**DETERMINATION OF BIOLOGICALLY EQUIVALENT
OR SUPERIOR PRESERVATION (DBESP) ANALYSIS**

**SEATON TECH CENTER
DEVELOPMENT PROJECT
LOCATED IN THE COMMUNITY OF MEAD VALLEY,
RIVERSIDE COUNTY, CALIFORNIA**

SUBJECT: Seaton Tech Center (PPT 180025), Located in the County of Riverside County, California: Wildlife Agency Comments to DBESP.

Subject: DBESP for the Seaton Tech Center Project (PPT180025),
Mead Valley Area Plan, County of Riverside

**SEATON
COMMERCE CENTER PROJECT**
Photo Locations Map

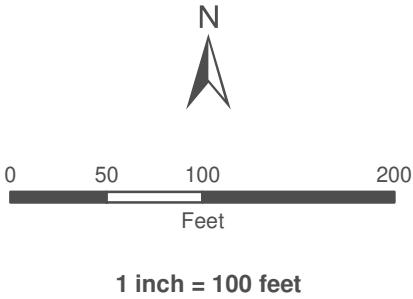
The Wildlife Agencies are concerned that the riparian/riverine delineation provided in the DBESP does not appear to represent the full extent of the MSHCP riparian/riverine resources on the Project site. The DBESP identified two riparian/riverine drainage features (Drainage A and Tributary A-1) on the Project site. However, aerial imagery from multiple years shows Drainages “A” and “A-1” supporting riparian/riverine vegetation beyond the width of the areas identified

as riparian/riverine resources in the proposed DBESP. Additionally, stream widths that appeared wider in some areas than those identified in the riparian/riverine delineation were observed by Wildlife Agency staff in February 2020 from streets adjacent to the Project site. The Wildlife Agencies request that the County revise the delineation to include the full widths of the on-site riparian/riverine resources or a site visit to validate the existing delineation.

Although GLA believed that the limits of jurisdiction noted in the jurisdictional delineation provided as part of the Determination of Biologically Equivalent or Superior Preservation (DBESP) were accurate, based on e-mail communication with Eric Chan, we agreed to re-review the areas in question identified by the Wildlife Agencies. GLA regulatory specialists again walked both Drainage A and Drainage A-1 onsite on March 27, 2020, and determined that the widths of each drainage feature were accurately documented in the biological technical report containing the jurisdictional delineation prepared by GLA and dated October 10, 2019, and in the DBESP report prepared by GLA and dated November 8, 2019.

GLA again reviewed historical aerial photographs from 1966, 1978, 1994, 2002, 2005, 2009, 2012, and 2016, all of which corroborated the widths that we had documented in Drainages A and A-1.

Furthermore, the Wildlife Agencies were concerned that riparian habitat is present on site, but we confirmed that the vegetation in question is actually upland brome species and cheeseweed, despite the “green” color on the aerial photographs. Please see attached new photographs, taken on the site on March 27, 2020.

Attached to this letter is a map with photograph points for Drainages A and A-1, and the accompanying photographs, to show again to the County and Wildlife Agencies that the widths and attached documentation demonstrate the lack of riparian habitat onsite. This letter serves as a response to comment which confirms for the County and the Wildlife Agencies that the information contained in our biological technical report containing the jurisdictional delineation dated October 10, 2019, and in the DBESP dated November 8, 2019, are accurate. Therefore, neither the jurisdictional delineation nor the DBESP require revisions.
